Relevant Information for Central Sydney Planning Committee

FILE: D/2024/446 **DATE:** 8 May 2025

SUBJECT: Information Relevant To Item 8 – State Significant Development Application:
372-382A Pitt Street, Sydney – D/2024/446

Figure 1: proposed ground floor plan with current location of hydraulic booster and proposed relocation

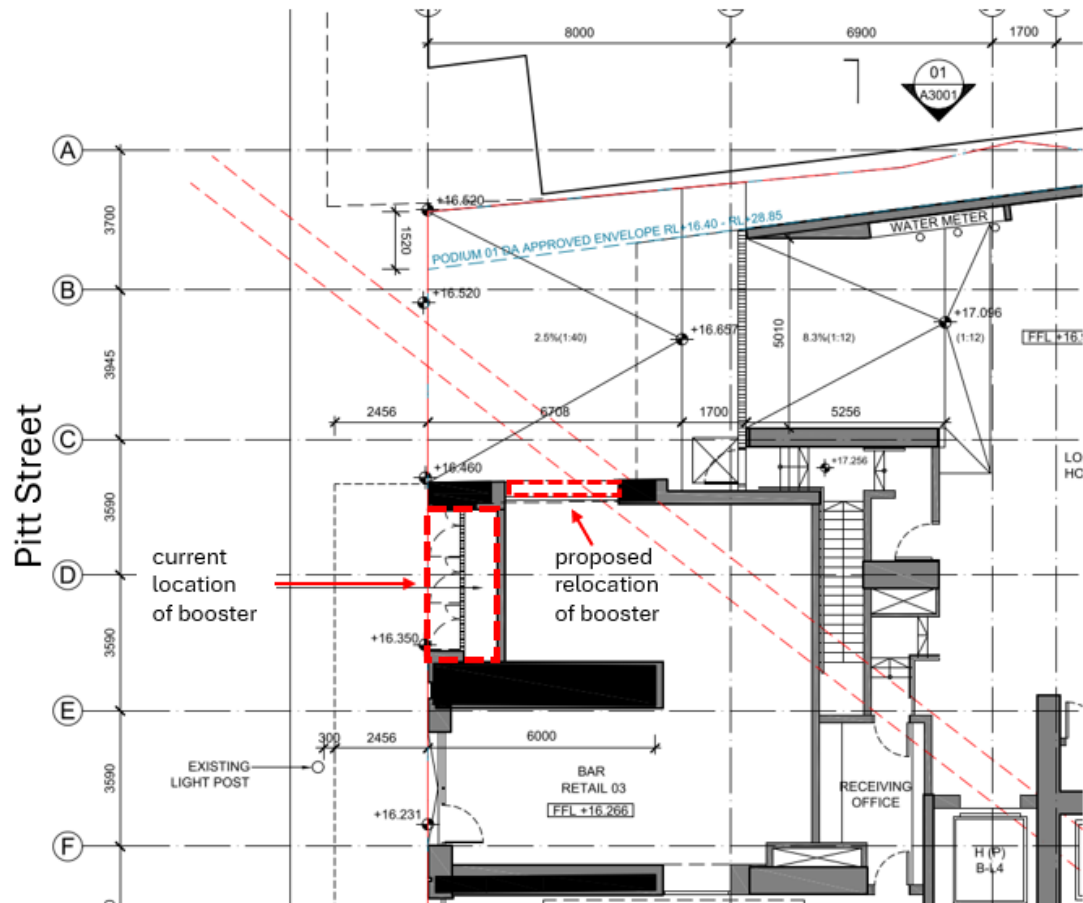
The applicant has also requested that subsection (b) be deleted for the following reasons:

- the driveway location for the hydraulic booster is not suitable as the driveway appears to be only 5m wide, where Fire and Rescue NSW (FRNSW) requires a

minimum 6m wide hardstand area; and there does not appear to be sufficient space to manoeuvre a fire truck.

The deletion of subsection (b) in relation to the relocation of the hydraulic booster is not supported. A hydraulic booster occupying a full shopfront bay facing Pitt Street is a poor urban design outcome as it will limit ground floor activation. Additionally, the applicant has not provided correspondence from FRNSW confirming that the location is unsuitable.

The condition requests the booster be relocated from the Pitt Street elevation to the northern elevation / side wall of 374 Pitt Street, facing the driveway. The location is setback 2.1m from the Pitt Street boundary of the site.

The *Fire Safety Guideline Access for Fire Brigade Vehicles and Firefighters* by FRNSW requires a driveway width to be a minimum 6m if a fire safety vehicle is required to enter the site, to allow easy negotiating by the vehicle and provide room around the vehicle to allow firefighters to exit and use equipment (Guideline 7.1). The hardstand area utilised by the vehicle is to be within 8m of any fire hydrant booster assembly (Guideline 8.2).

A fire safety vehicle is expected to stop in front of the site on Pitt Street to access the hydraulic booster in its current location and given the close proximity of the booster to the boundary if relocated, will likely still utilise Pitt Street for access rather than the driveway. The fire safety vehicle, if stopped on Pitt Street, is located approximately 5.2m from the relocated booster.

- (b) The hydraulic booster is to be relocated from the Pitt Street elevation to the northern elevation/side wall of 374 Pitt Street at ground floor, and the historical shopfront be reconstructed.
